Report to Committee

Re: **APPLICATION BY BOSA PROPERTIES INC. FOR REZONING AT 5811 AND 5851 NO. 3 ROAD FROM AUTOMOBILE-ORIENTED COMMERCIAL DISTRICT (C6) TO DOWNTOWN COMMERCIAL DISTRICT (C7)**

RZ 04-267103

MINUTES FROM THE ADVISORY DESIGN PANEL MEETING
Wednesday, March 17th, 2004 – 4 pm
Room M1.003, Richmond City Hall

EAST & SOUTH
 ELEVATIONS

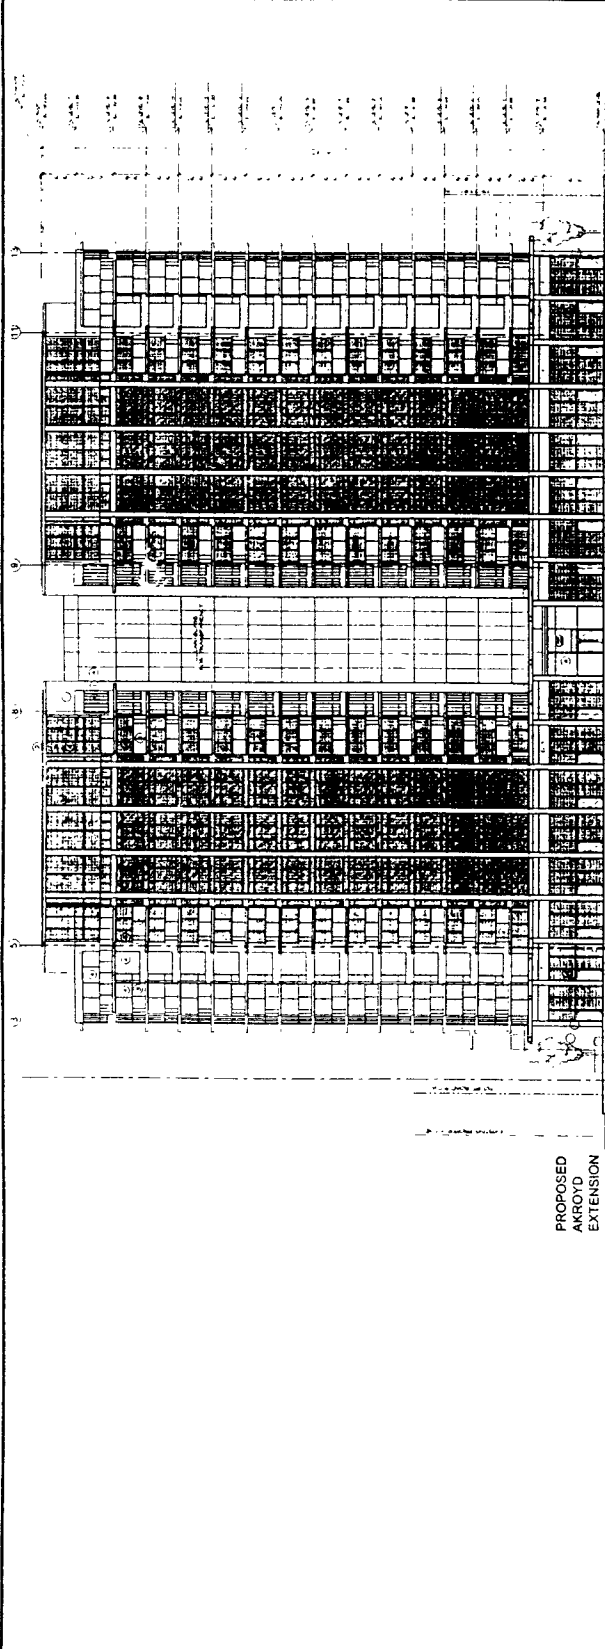
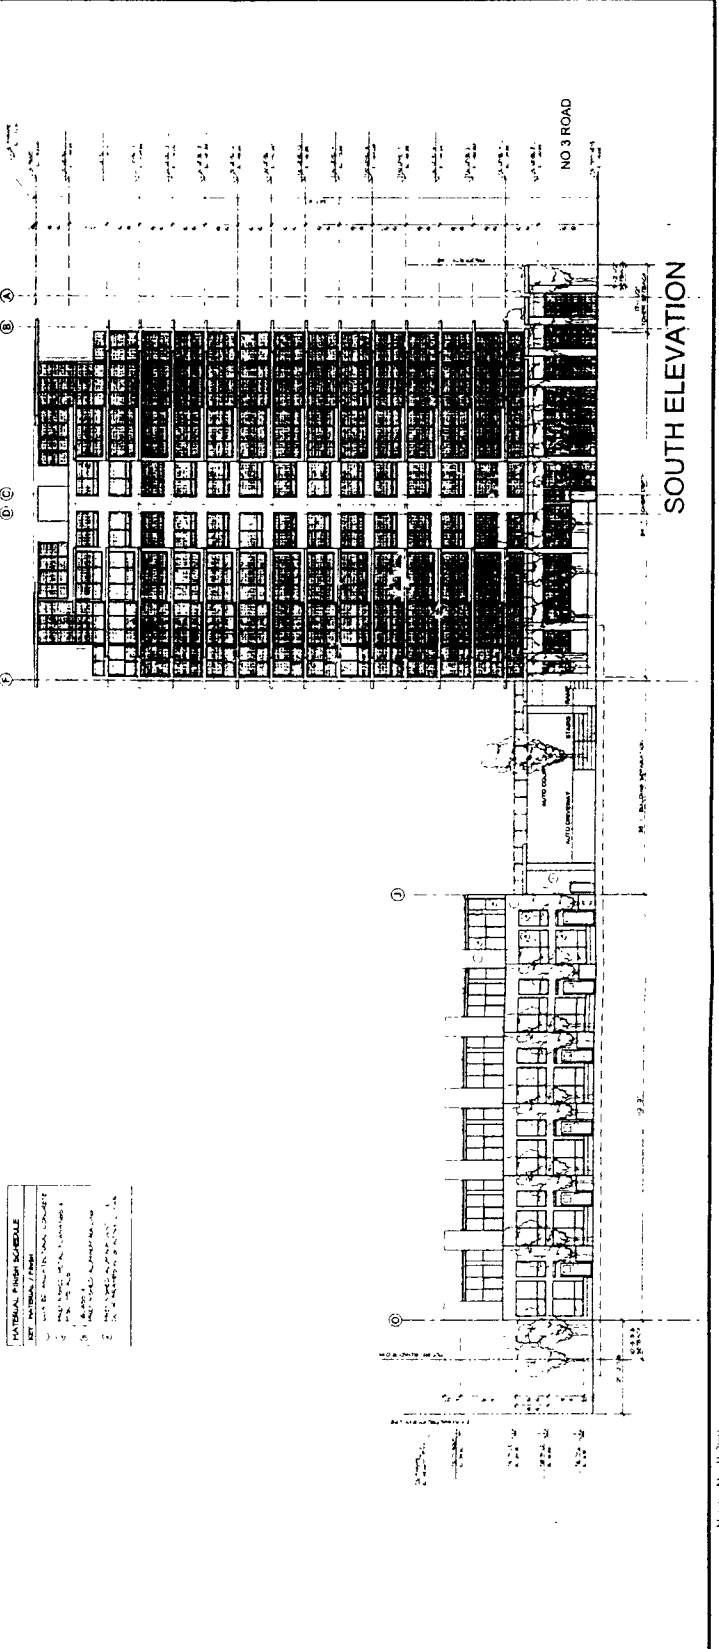
The subject project's unusually large tower floorplates are a major departure from the City Centre Area Plan Development Permit (DP) Guidelines. This tower form poses a significant design challenge that must be addressed in order for the project to be a "good neighbour" and a desirable precedent for development elsewhere in the City Centre. As such, through the course of the DP stage, the applicant should seek to demonstrate clear advantages of a single large slab tower over a more conventional twin tower form including, but not limited to, the provision of:

- Design the project to respond to both its interim situation as a mid-block site and its future situation at a prominent downtown intersection, near a possible light rapid transit station (e.g. likely south of Ackroyd Road), through massing, tower/lower-level building features, landscaping/public open space features, etc. that focus attention on the project's important southeast corner;

- Design the lower levels of the No. 3 Road façade to better balance with the very large scale of the tower above and to further enhance the attractiveness, visual interest, and amenity of the streetscape for pedestrians and retailers;

- Provide continuous pedestrian weather protection along the site's commercial frontages and across the entrance to the project's auto-court in the form of substantial glazed canopies and, as much as possible, extend this treatment along the frontages of the project's work/live units (i.e. at units entries and/or corner features near the lane and the auto-court entry);
